SUNDRY NOTICES AND REPORTS ON WELLS

POKER LAKE UNIT #58

Poker Lake #58
Well Bore Sketch

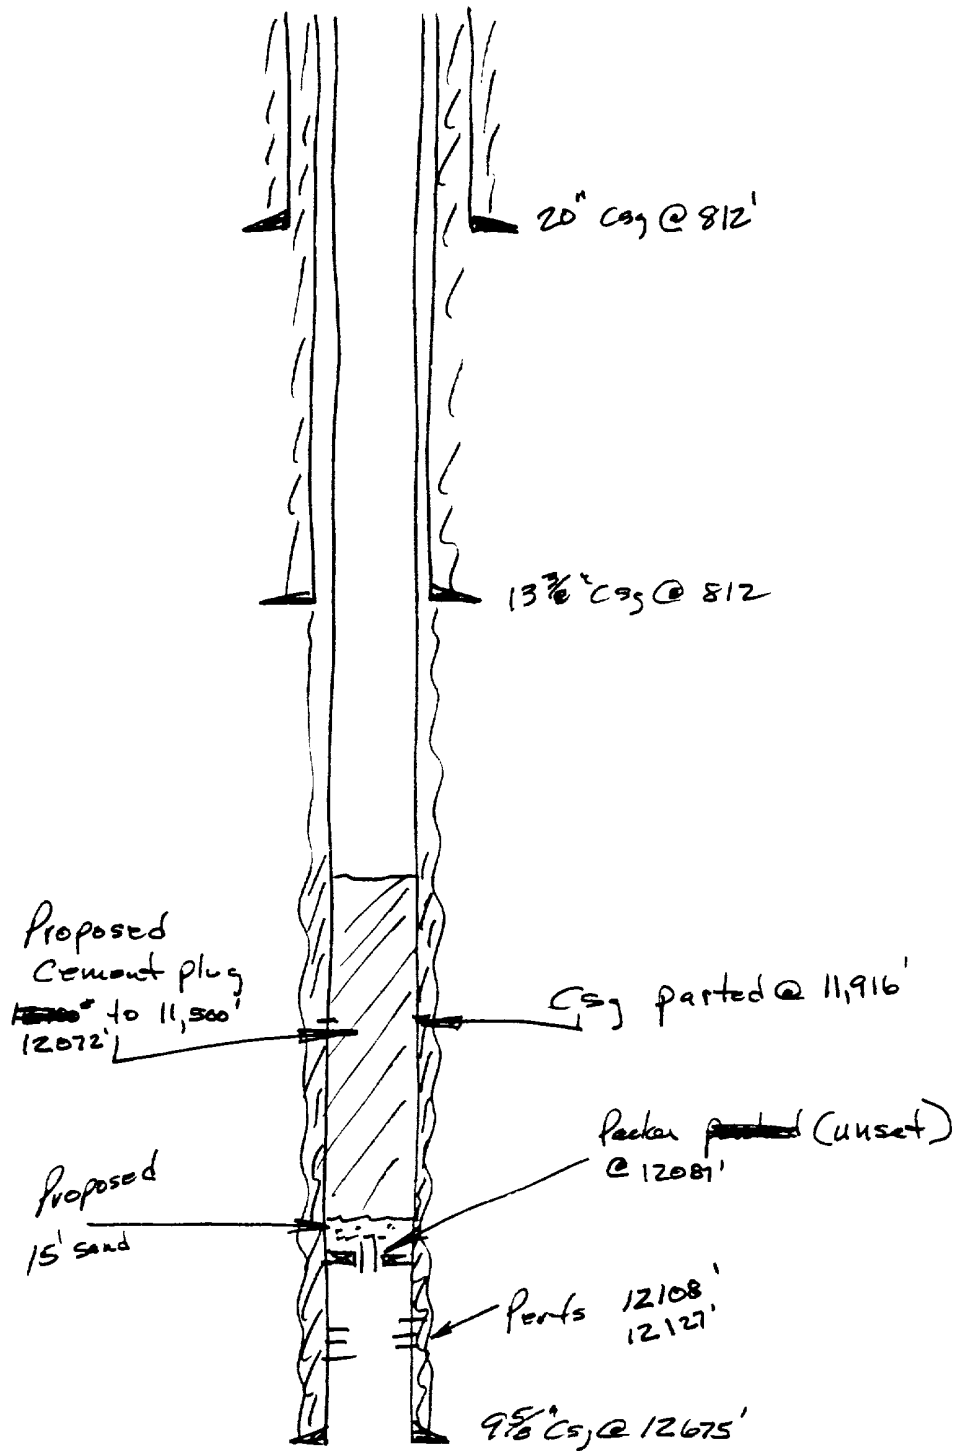
DUE TO COLLAPSED CASING, THE FOLLOWING IS PROPOSED: THE 9-5/8" CASING WAS FOUND PARTED AT APPROXIMATELY 11,916' DURING ROUTINE OPERATIONS TO REMOVE A PERMANENT PACKER SET AT 11,898'. THE PACKER HAS BEEN KNOCKED LOOSE AND FELL TO APPROXIMATELY 12,100' (ABOVE PERFS AT 12,108'-12,147'). IT IS PLANNED TO RUN INSIDE THE PARTED 9-5/8" CASING WITH 2-7/8" TUBING AND SPOT 6 SACKS (+/-15') OF 20/40 SAND ON PACKER. THEN SPOT 600' CLASS "H" CEMENT INSIDE THE 9-5/8" CASING FROM 12,100' TO 11,500'.
